SURFACEWATER IMPROVEMENT PROJECT

Bend, OR

FINAL VALUE ENGINEERING STUDY REPORT

Prepared for:

SURFACE WATER IMPROVEMENT PROJECT
TRANSMISSION CONDUIT
UPPER CROSSING PLAN AND PROFILE
STA: 472+00 TO STA: 473+75
DESCHUTES COUNTY, OREGON

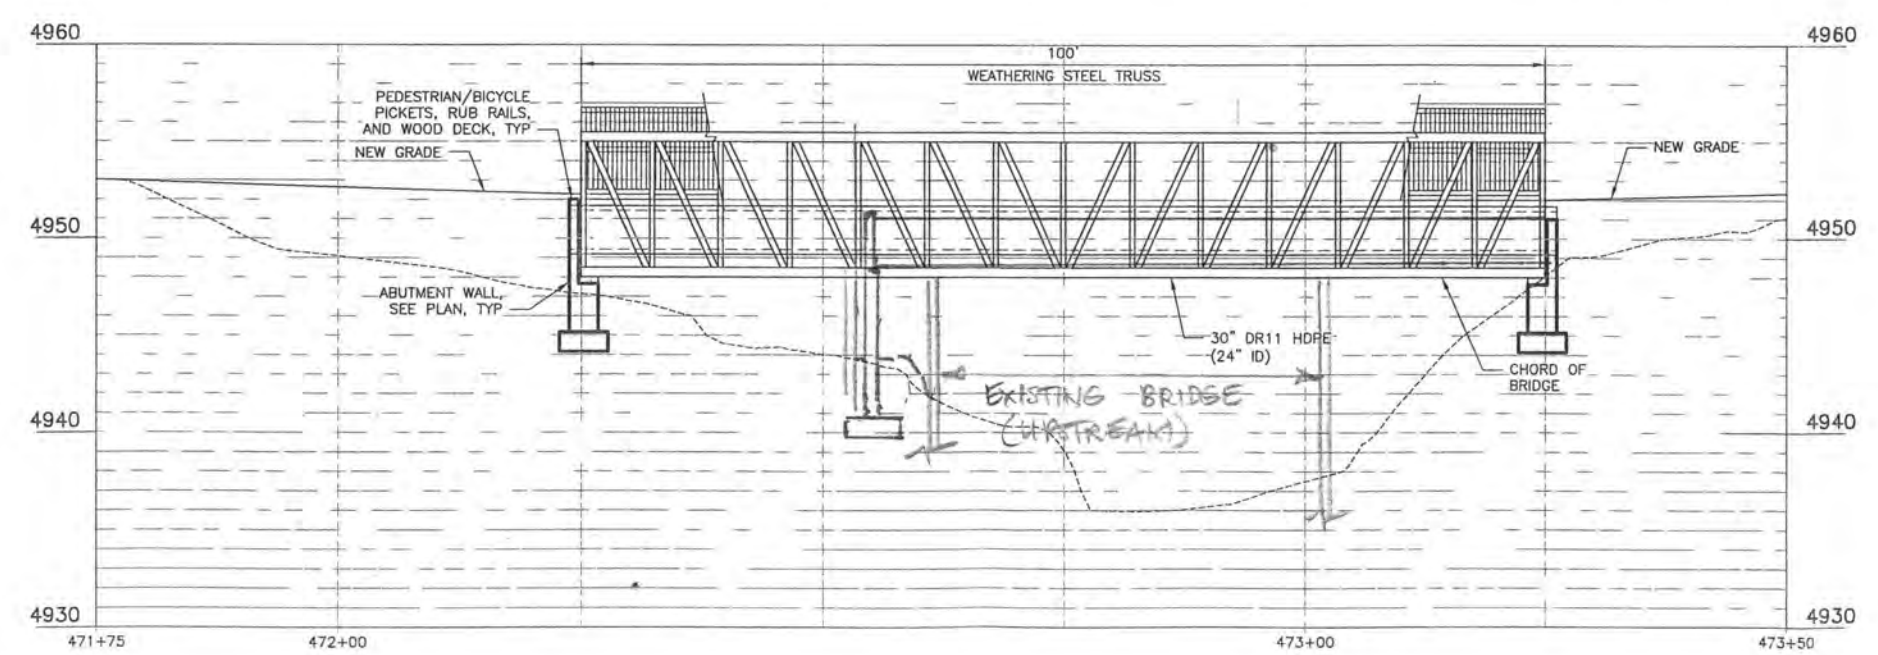
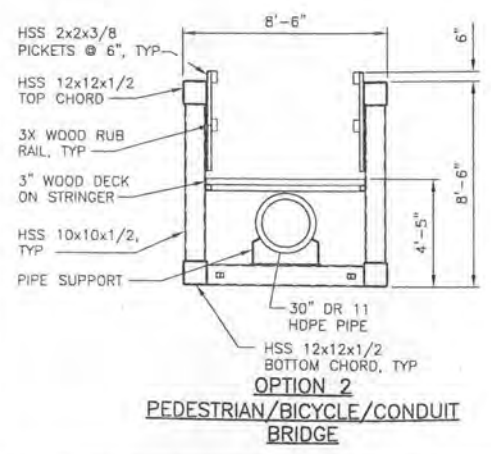
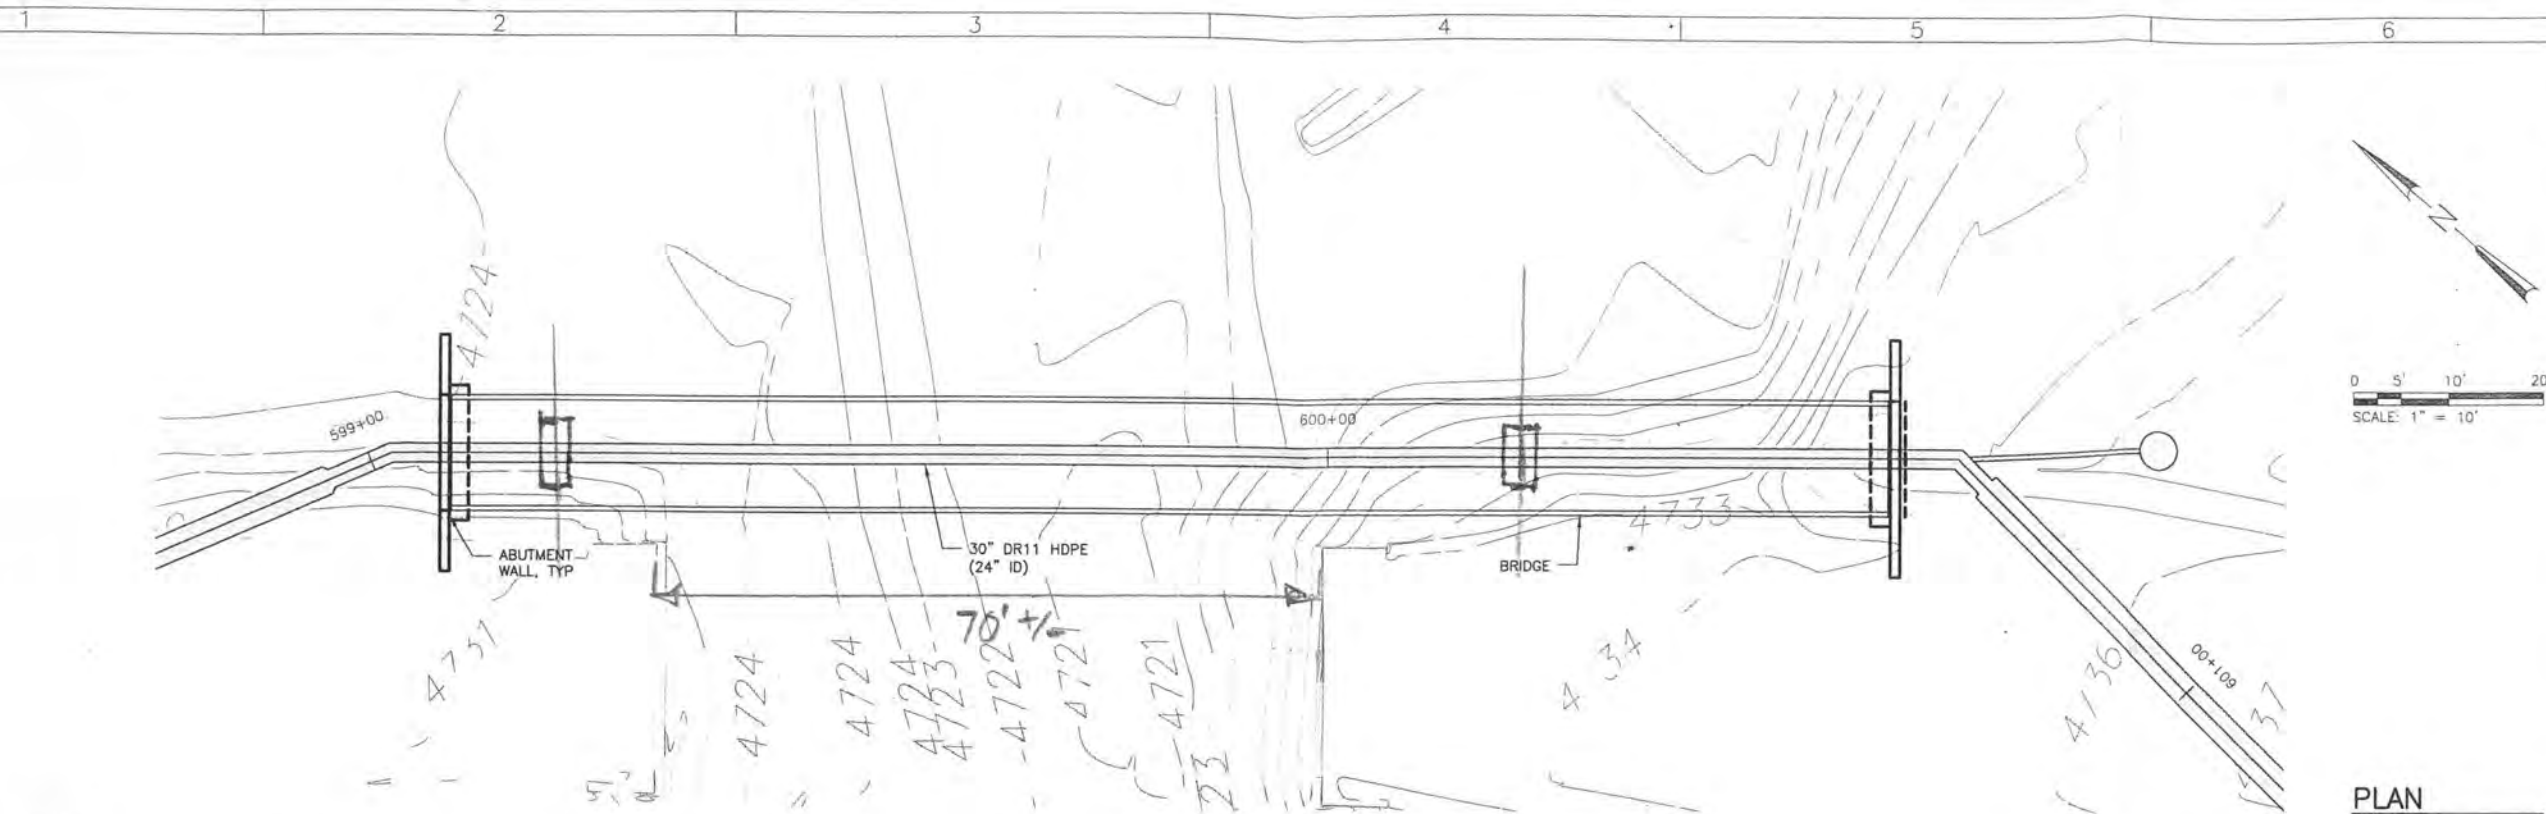
The original concept showed using weathered steel trusses to carry the water transmission pipe across two creek crossings that would also provide access for pedestrians/bicycles.

At the Upper Creek Crossing, there is an existing vehicle bridge adjacent to the pipe crossing that is approximately 40 feet long. At the Lower Creek Crossing, there is an existing vehicle bridge adjacent to the pipe crossing that is approximately 70 feet long. Based on these existing conditions, reduce the length of the new pipe crossings to reduce the span length. Reduce the span of the Upper Creek Crossing from 100 feet to 70 feet. Reduce the length of the Lower Creek Crossing from 150 feet to 100 feet.

The carrier pipe would be analyzed as a structural beam and the wall thickness would be increased sufficiently to span the creek. For estimating purposes, it was calculated that the pipe diameter would need to be increased to 48 inch diameter to provide the structural rigidity to span the creek and limit deflection for the Lower Creek Crossing. For the Upper Creek Crossing the pipe would be 36 inches in diameter.

SURFACE WATER IMPROVEMENT PROJECT
TRANSMISSION CONDUIT
LOWER CROSSING PLAN AND PROFILE
STA: 599+00 TO STA: 601+00
DESCHUTES COUNTY, OREGON

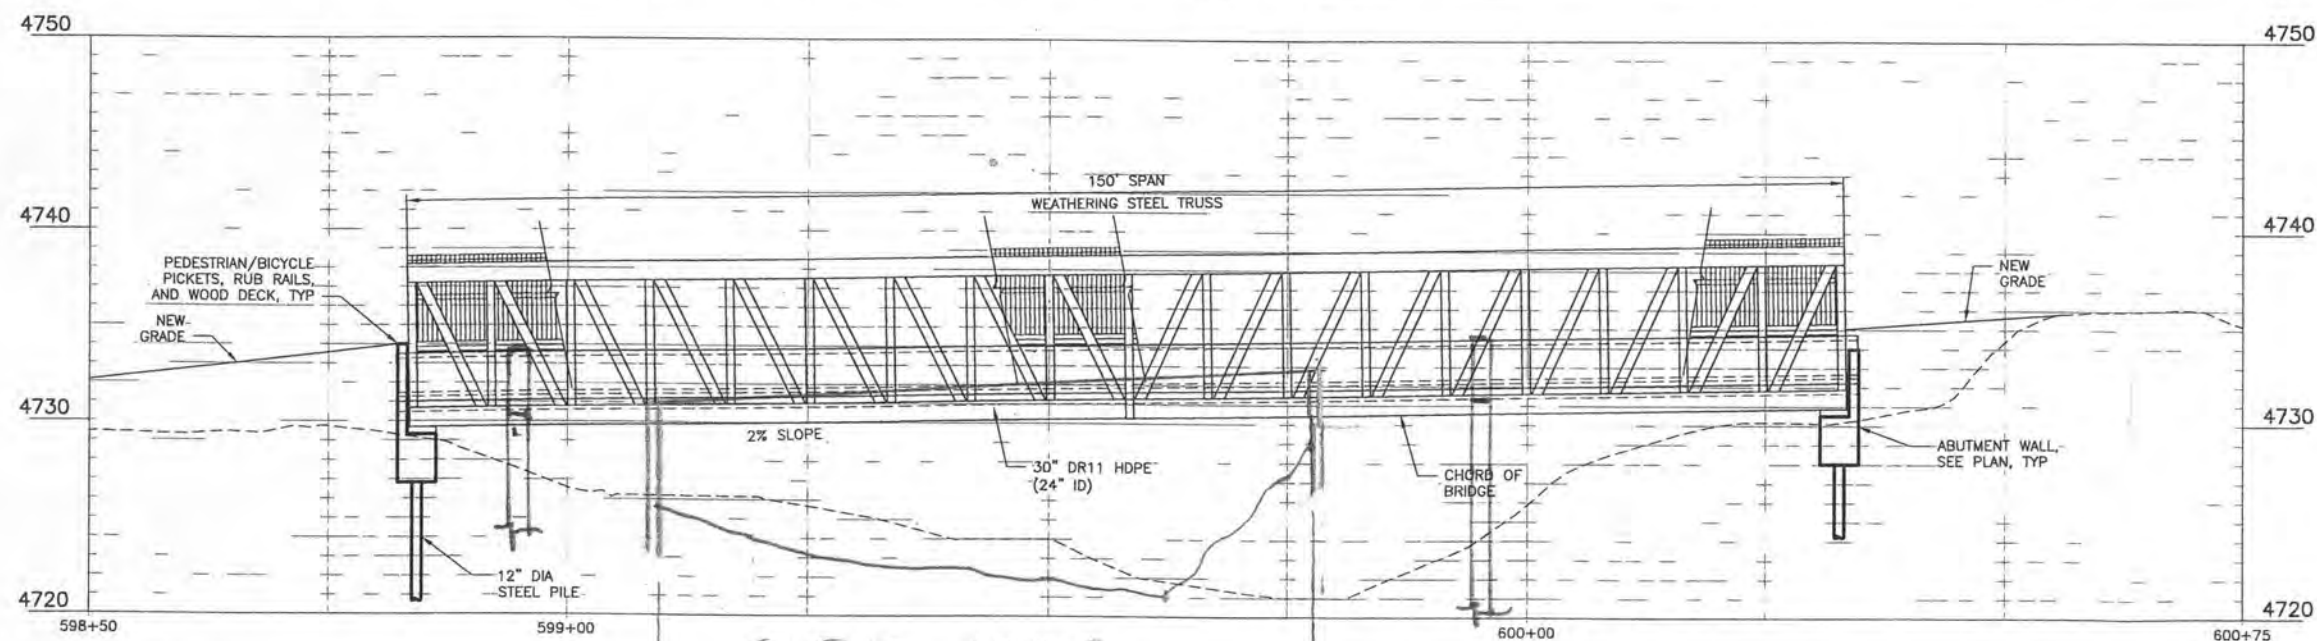
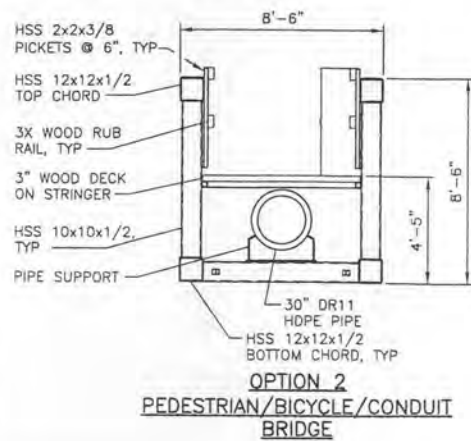
One advantage of steel over HDPE is that the coefficient of expansion is much less for steel. This is a major issue for HDPE where the expansion of the HDPE pipe at the Lower Crossing could be as much as 6 inches for a 150 length of pipe over a 40 degree temperature change.

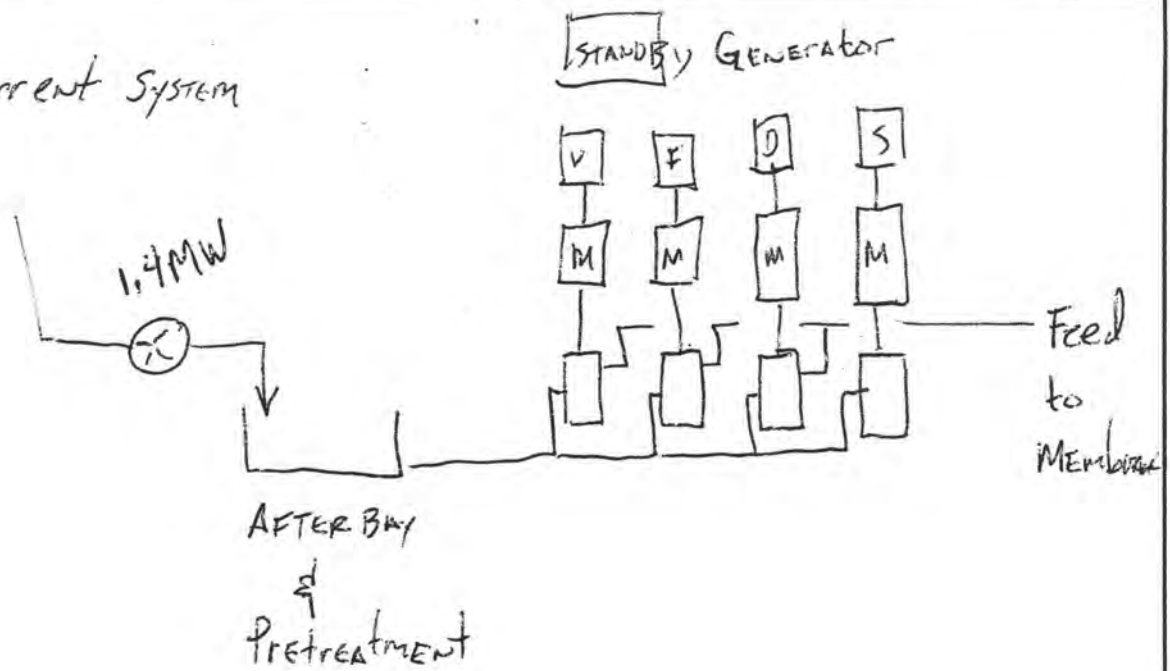
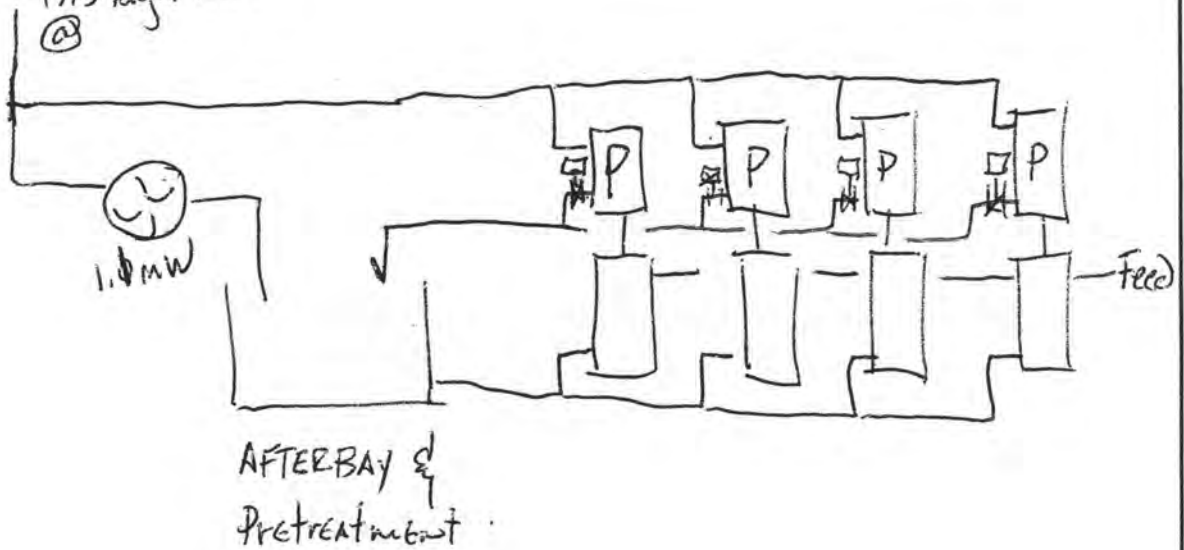
The current design generates electricity from a turbine which is transformed to a higher voltage. Electricity is then purchased for the operation of the membrane feed pumps. The design eliminates the need for the mechanical electrical-electrical mechanical conversion by coupling a similar pelton wheel turbine to the shaft of the membrane feed pump. Not only does this alternative eliminate the need for a VFD drive and motor for the membrane feed pump, it also reduces the size of the standby electrical generator that would be required in the event of a power generation failure, as the membrane feed pumps are not powered by electrical energy.

The turbine can be reduced in size, because a portion of the power is used by the membrane feed pumps.

Each feed pump would be controlled by a valve that would serve to throttle the volume of water and act in a manner similar to a VFD to obtain a similar method of control.

The proposed arrangement is conceptual in nature, as the specifics for range-ability, control and hydraulic response were not evaluated. One potential solution to further minimize pressure and flow variations to the membrane feed system is to use a hydro-pneumatic tank to further dampen pressure and flow changes.

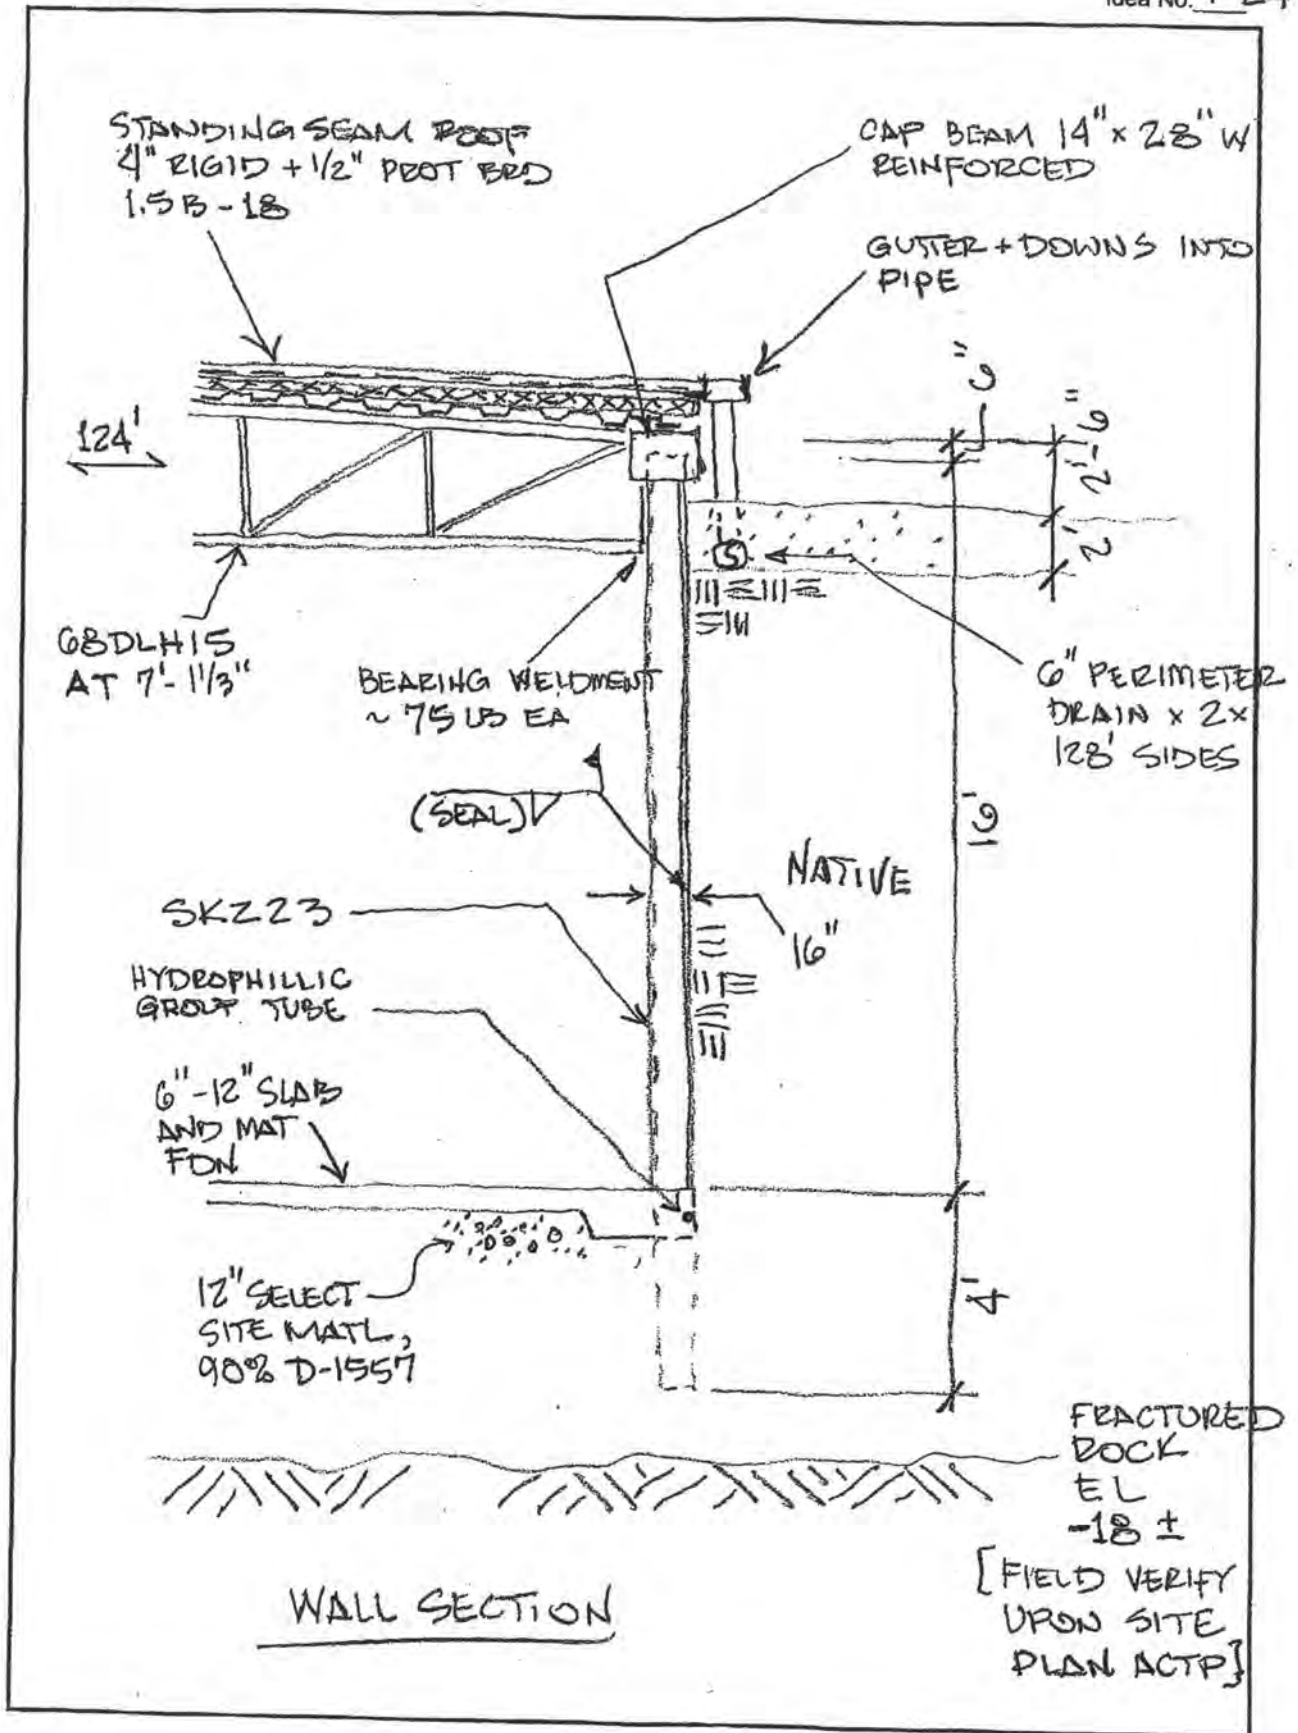
The geotechnical report indicates fractured basalt approximately 18 feet below grade with dense but not cemented granular (to 20" cobbles) material above. Groundwater is more than 450 feet below grade. This indicates the ability to drive adequately designed piling to provide shoring and permanent walls. The sheetpiling may be restrained at top during construction with tieback/deadmen. To ensure installation the cost estimate includes percussion drilling the perimeter to break up cobbles and boulders which may be present.

Placing the structure below grade eliminates the need for expensive, architectural wall systems and insulation. Heating needs are reduced and ventilation remains unchanged. The excavated material is bermed up two feet around the building but the roof is set another 2.5 feet above grade to prevent vehicle/equipment access. It is a typical roof.

Access is provided by two above-grade penthouses leading to stairways. A passenger elevator is also included to serve various needs. Equipment install/removal can be accomplished through two, 6'x6' roof hatches.

The current design includes indoor space for chemical tanks as does this idea. These might better be placed outdoors (weather insulated/heat-traced) on slabs to reduce the size of this building and ease access for filling.
